(This bulletin obsoletes Service Bulletins M20-8, M20-134, and M20-150.)

**SUBJECT:** MAGNETIC COMPASS INTERFERENCE

**FIGURE 1**

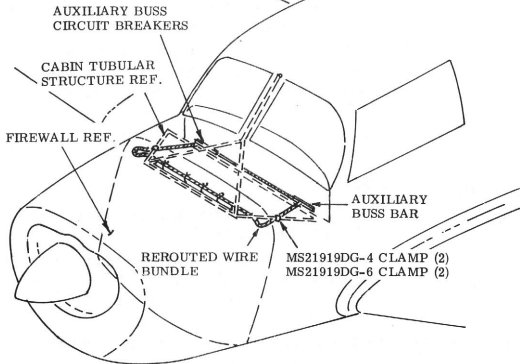
Refer to Figure 1 on page 8 and to magnetic attraction possibility number 1 in the Introduction.

Models Affected: M20B, S/N 1701 thru 1851, 1853 thru 1939  
M20C, S/N 1852, 1940 thru 3466, 670001 thru 670129  
M20D, S/N 101 thru 260  
M20E, S/N 101 thru 1308, 670001 thru 670062  
M20F, S/N 660002 thru 660004, 670001 thru 670362

- Step 1 Remove wires connecting "Aux Buss" circuit breaker and auxiliary buss bar. There are wire numbers: 800007-9 on M20B; 800007-169 on M20C, M20D, and M20E; and 800214-001 on M20F aircraft.
- Step 2 Select circuit breaker-to-buss bar wires having a 60-inch length of No. 6 MIL-W-5086, Type 2, wire with AMP 321298 terminals on each end. Mooney-manufactured wires conforming to these specifications carry wire number 800007-292 for M20B, M20C, M20D, and M20E; and 800214-147 for M20F aircraft (Refer to S.B. Kits Nos. M20-150A-1 & -2).
- Step 3 Route replacement wire forward from "Aux Buss" circuit breaker to firewall. Run wire across firewall with existing wire bundle and then straight aft to auxiliary buss bar.
- Step 4 Use cushioned clamps to attach wire to tubular structure, and string-tie wire to existing wire bundles across firewall.
- Step 5 Proceed with Step 1 of Instruction III.
